**NEW YORK STATE THRUWAY AUTHORITY
DEPARTMENT OF ENGINEERING**

**AMENDMENT NO. 1
TO**

**CONTRACT TAS 24-20B
D214978
REPLACEMENT OF THE I-90 BRIDGE OVER
ORISKANY BOULEVARD (NY 69) AT MILEPOST 238.22
IN THE SYRACUSE DIVISION
OF THE NEW YORK STATE THRUWAY
IN ONEIDA COUNTY**

**IN THE LETTING OF
MAY 29, 2024**

TITLE OF PROJECT REPLACEMENT OF I-90 BRIDGE OVER ORISKANY BOULEVARD	CONTRACT NUMBER: TAS 24-20B
LOCATION OF PROJECT SYRACUSE DIVISION MP 238.22	DATE: 04/03/2024
TITLE OF DRAWING TRAFFIC STOPPAGE PLAN	DRAWING NUMBER: TC-1

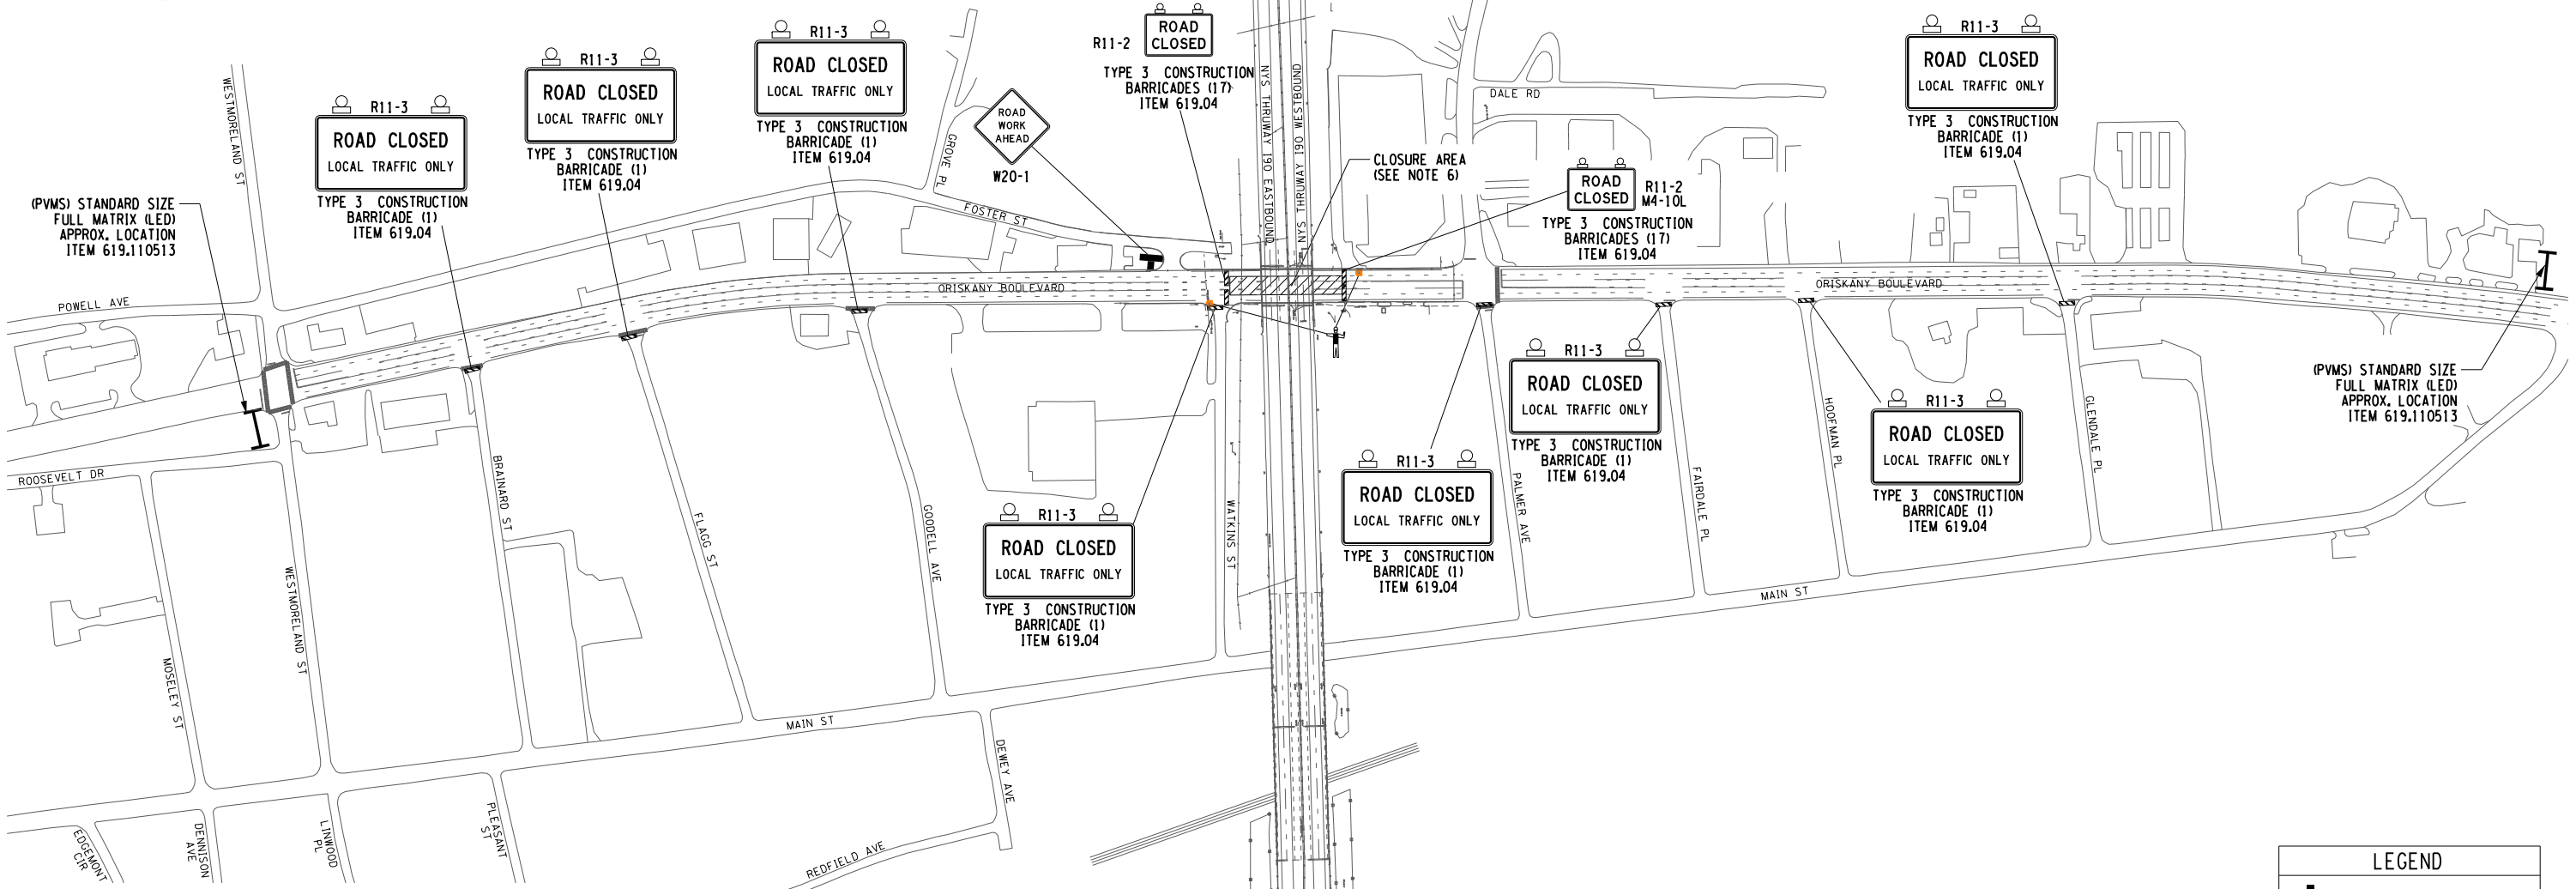
2. **DELETE** Drawing TC-1, Sheet 14, and **SUBSTITUTE** with the attached Drawing TC-1, Sheet 14A1. Note 4 was revised to also require seven (7) calendar days advance notice to the Mohawk Valley Transportation Management Center (MVTMC) prior to any construction activities requiring the stopping of traffic on Oriskany Boulevard (NY 69).

4. THE NEW YORK STATE POLICE AND THE MVTMC SHALL BE GIVEN SEVEN (7) CALENDAR DAYS NOTICE BY THE ENGINEER WHEN CONSTRUCTION OPERATIONS REQUIRE STOPPING TRAFFIC. THE CONTRACTOR SHALL SCHEDULE OPERATIONS ACCORDINGLY AND PROVIDE THE ENGINEER ADEQUATE NOTICE (MINIMUM OF 2 WEEKS). FAILURE OF THE CONTRACTOR TO PROVIDE ADEQUATE NOTICE TO THE ENGINEER WILL RESULT IN DELAYS TO THE CONTRACTOR'S SCHEDULED OPERATIONS.

TITLE OF PROJECT: REPLACEMENT OF I-90 BRIDGE OVER ORISKANY BOULEVARD
LOCATION OF PROJECT: SYRACUSE DIVISION MP 238.22
TITLE OF DRAWING: PROPOSED BRIDGE PLAN AND ELEVATION

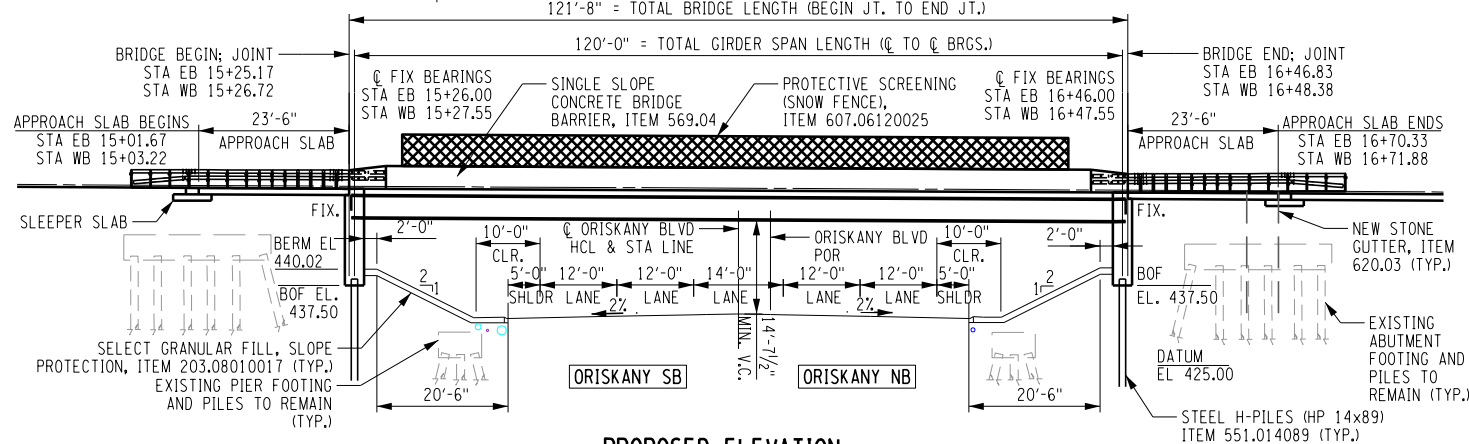
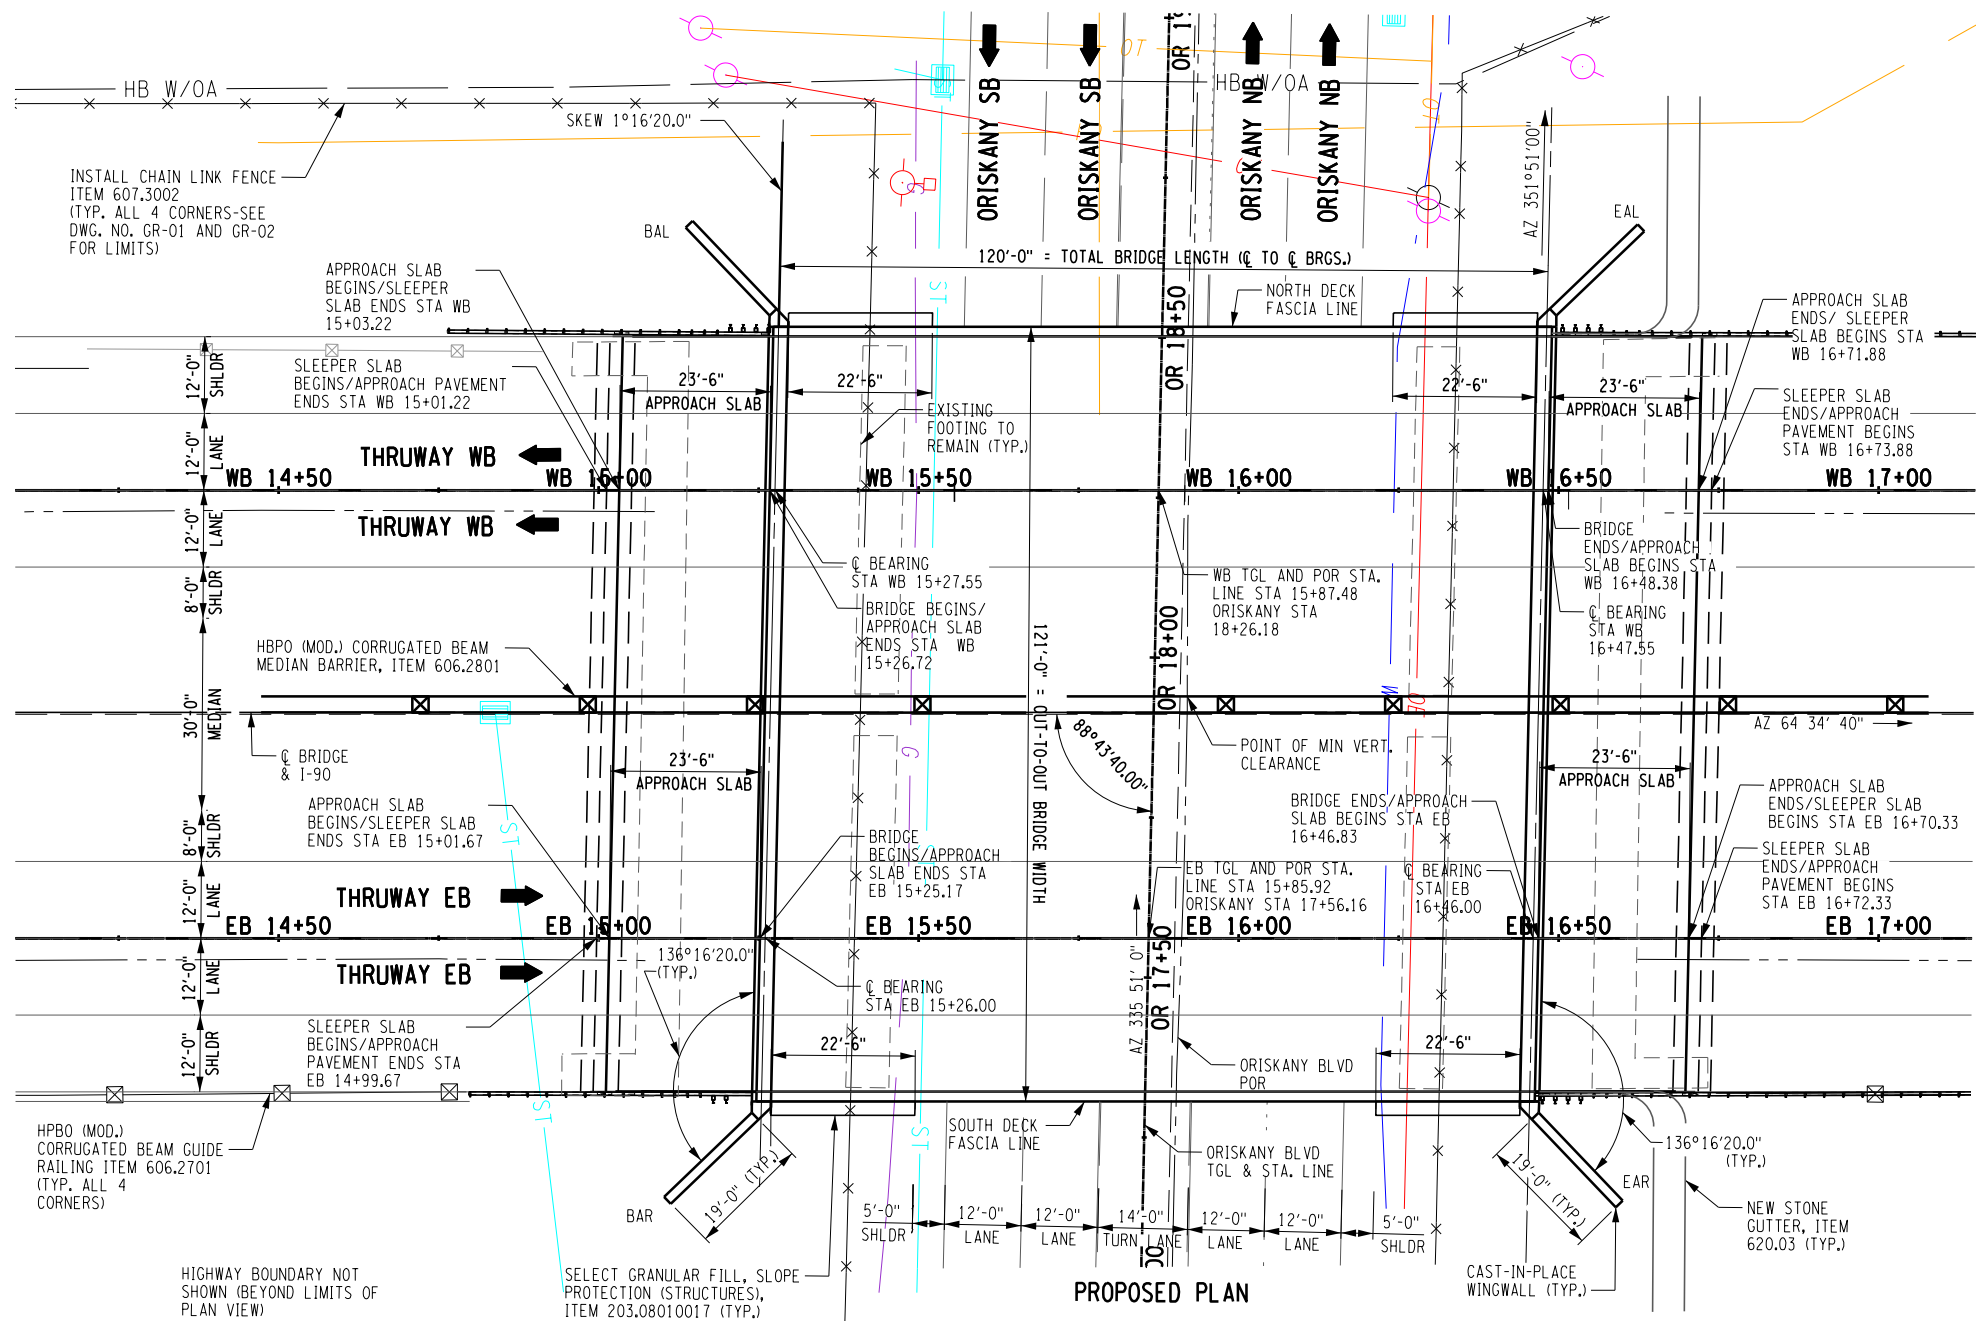
3. **DELETE** Drawing ST-2, Sheet 61, and **SUBSTITUTE** with the attached Drawing ST-2, Sheet 61A1. The clear zone on the Proposed Bridge Elevation was revised from 15'-0" to 10'-0" and Note 1 was added detailing the determination of the clear zone by the NYSDOT.

NOTES:
1. ORISKANY BOULEVARD (SR 69) IS UNDER THE JURISDICTION OF THE NYSOT, AND THE NYSOT SUPPORTS AND RECOMMENDS THAT A 10'-0" WIDE CLEAR ZONE BE USED UNDERNEATH THE NEW I-90 BRIDGE OVER ORISKANY BOULEVARD (SR 69). PER THE NYSOT, THE 10'-0" CLEAR ZONE DETERMINATION IS CONSISTENT WITH THE PREVAILING CLEAR ZONE OF 8 TO 10 FEET ALONG ORISKANY BOULEVARD (SR 69), THERE ARE NO EXISTING CRASH PATTERNS ON ORISKANY BOULEVARD (SR 69) IN THE VICINITY OF THE BRIDGE INDICATING THE NEED FOR A WIDER CLEAR ZONE, AND A 10'-0" WIDE CLEAR ZONE WOULD ALLOW FOR THE FUTURE CONSTRUCTION OF SIDEWALKS WITHOUT HAVING TO REGRADE THE SLOPES BETWEEN THE EXISTING CURBS AND PROPOSED ABUTMENTS.

TITLE OF PROJECT REPLACEMENT OF I-90 BRIDGE OVER ORISKANY BOULEVARD	CONTRACT NUMBER: TAS 24-20B
LOCATION OF PROJECT SYRACUSE DIVISION MP 238.22	DATE: 04/03/2024
TITLE OF DRAWING EXCAVATION AND EARTHWORK SECTIONS	DRAWING NUMBER: ST-7

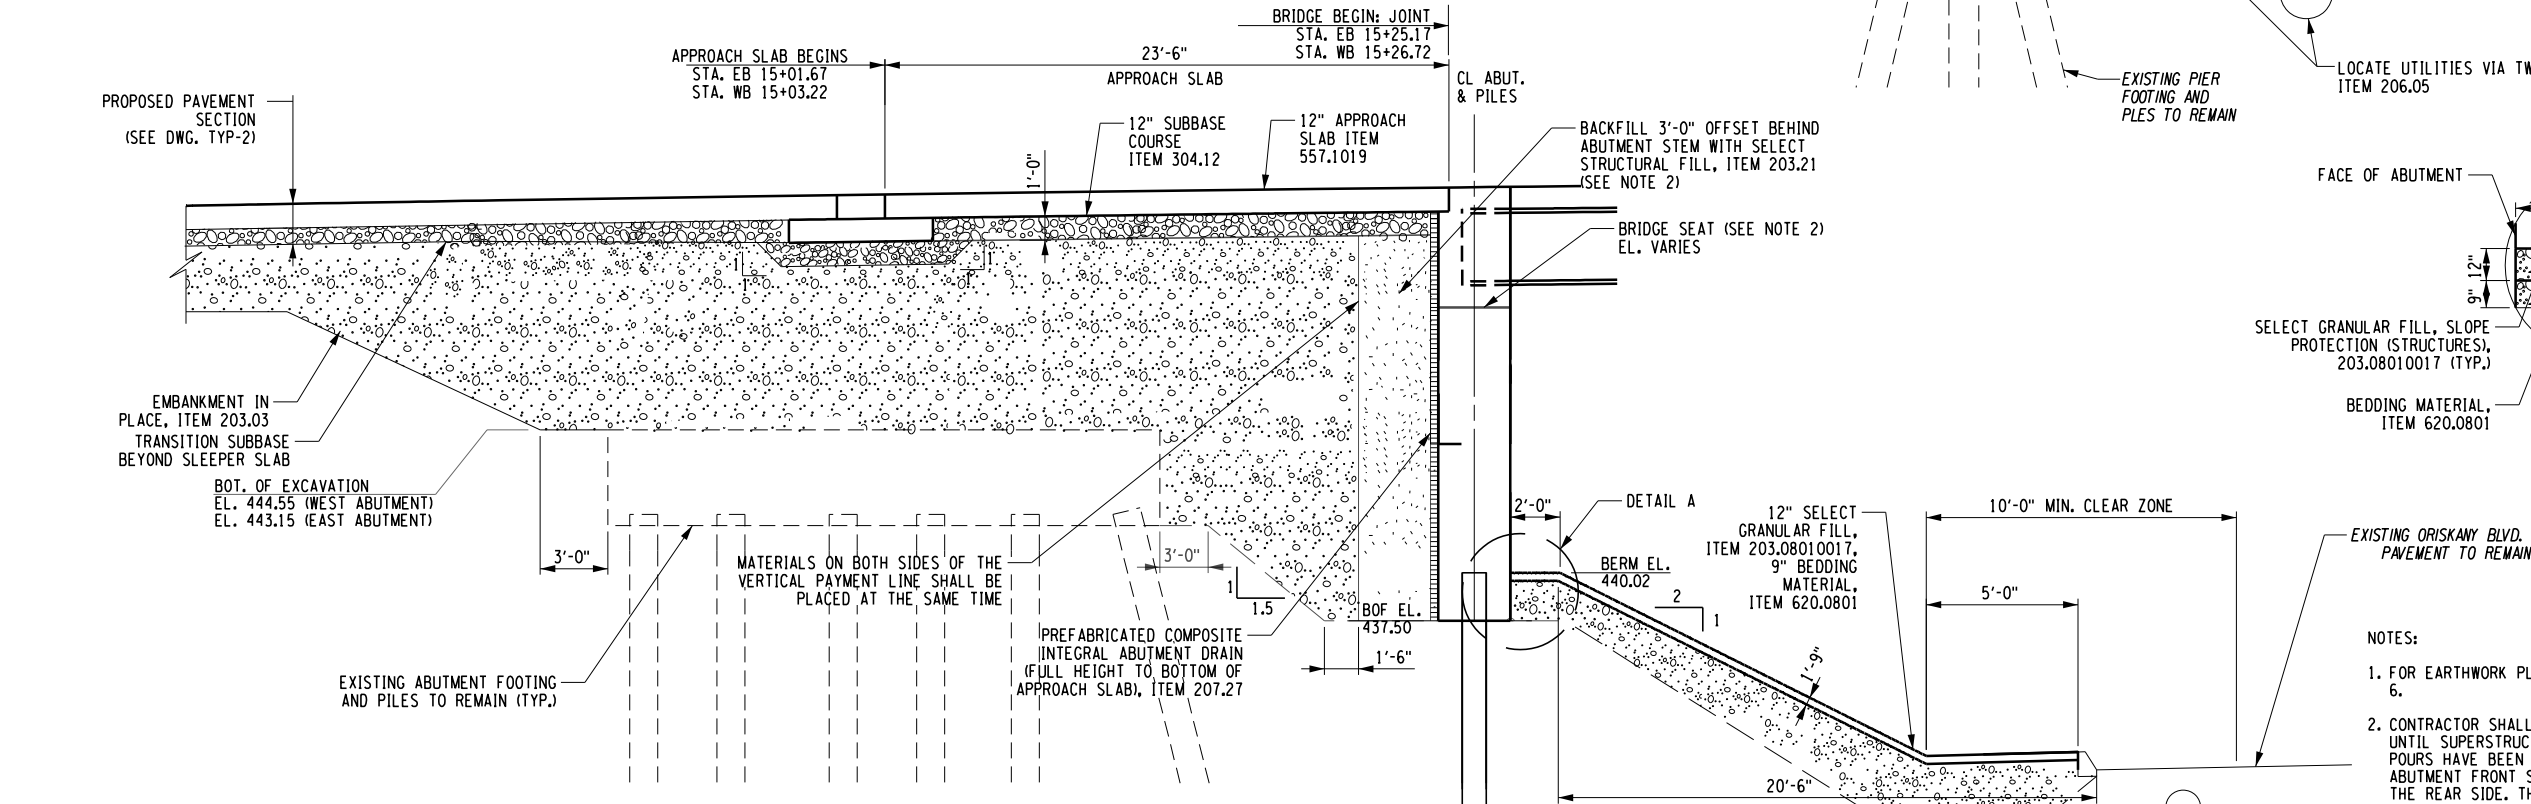
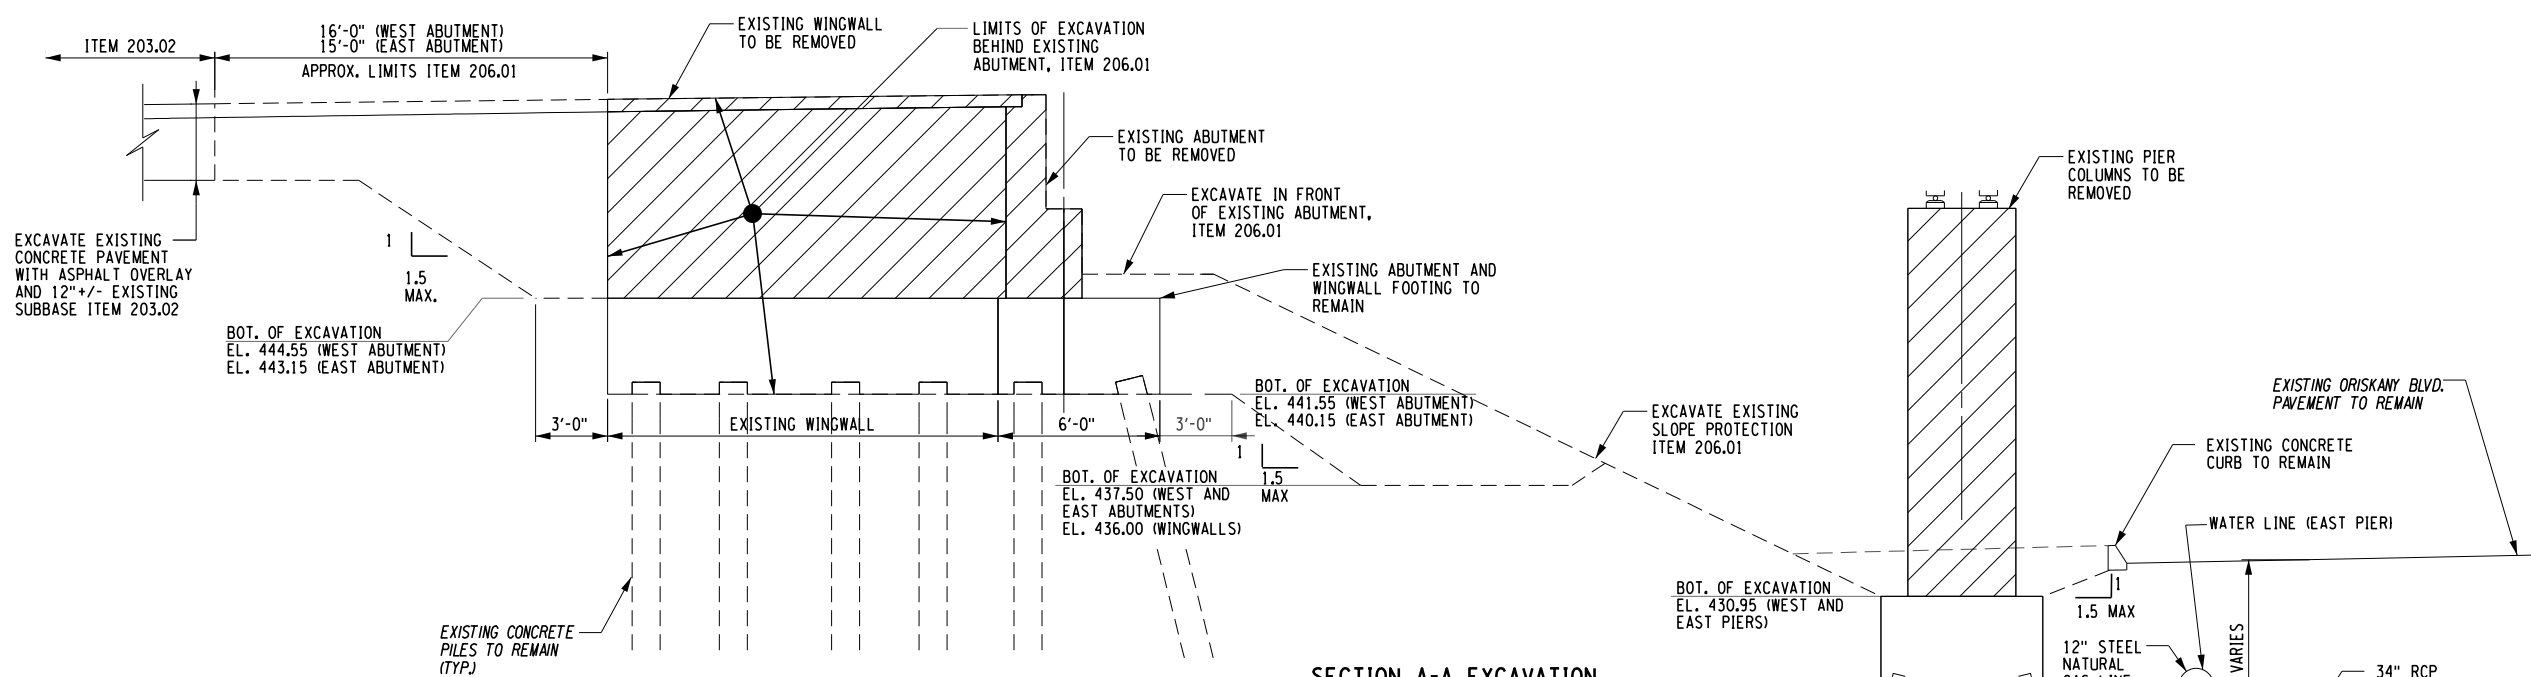
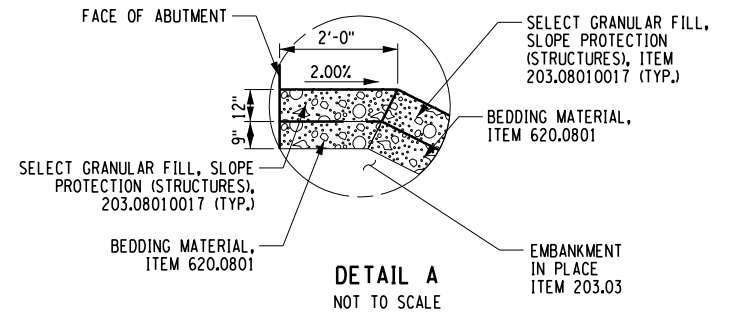
4. **DELETE** Drawing ST-7, Sheet 66, and **SUBSTITUTE** with the attached Drawing ST-7, Sheet 66A1. The clear zone on the Section A-A Backfill was revised from 15'-0" to 10'-0", the 1:3 slope on Section A-A Backfill was removed, the 1:2 slope was extended to meet the slope behind the existing sidewalk, and Note 3 was added detailing the determination of the clear zone by the NYSDOT.

3. ORISKANY BOULEVARD (SR 69) IS UNDER THE JURISDICTION OF THE NYS DOT, AND THE NYS DOT SUPPORTS AND RECOMMENDS THAT A 10'-0" WIDE CLEAR ZONE BE USED UNDERNEATH THE NEW I-90 BRIDGE OVER ORISKANY BOULEVARD (SR 69). PER THE NYS DOT, THE 10'-0" CLEAR ZONE DETERMINATION IS CONSISTENT WITH THE PREVAILING CLEAR ZONE OF 8 TO 10 FEET ALONG ORISKANY BOULEVARD (SR 69). THERE ARE NO EXISTING CRASH PATTERNS ON ORISKANY BOULEVARD (SR 69) IN THE VICINITY OF THE BRIDGE INDICATING THE NEED FOR A WIDER CLEAR ZONE, AND A 10'-0" WIDE CLEAR ZONE WOULD ALLOW FOR THE FUTURE CONSTRUCTION OF SIDEWALKS WITHOUT HAVING TO REGRADE THE SLOPES BETWEEN THE EXISTING CURBS AND PROPOSED ABUTMENTS.

SLEEPER SLAB DETAIL

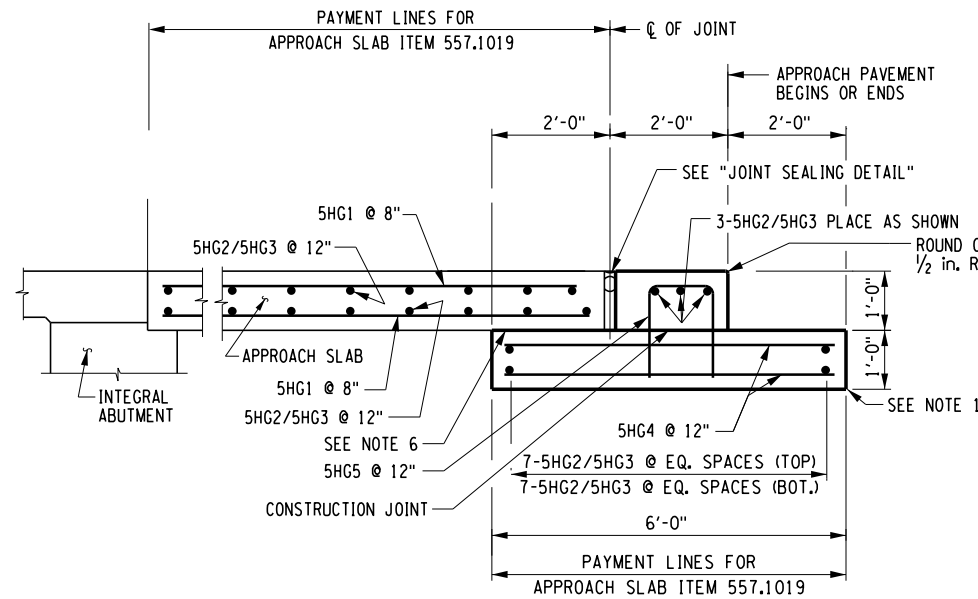
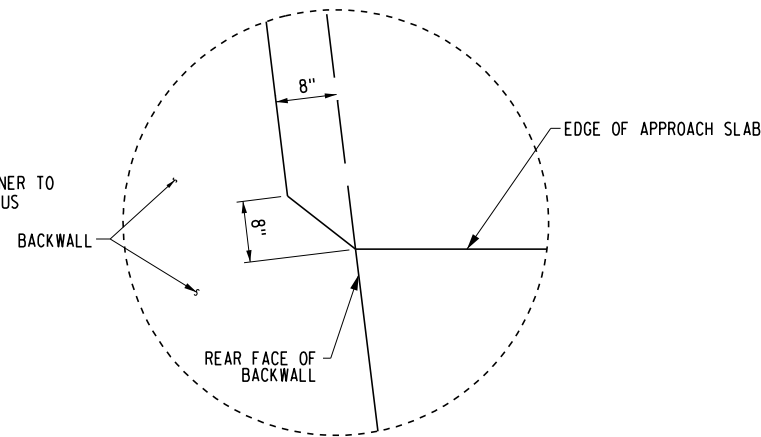
5. **DELETE** Drawing ST-49, Sheet 108, and **SUBSTITUTE** with the attached Drawing ST-49, Sheet 108A1. The sheet was revised to remove inapplicable tables and notes, more specifically, the Expansion Joint Opening Table, Notes 8 through 12, and the reference to Note 9 in the Sleeper Slab Detail.
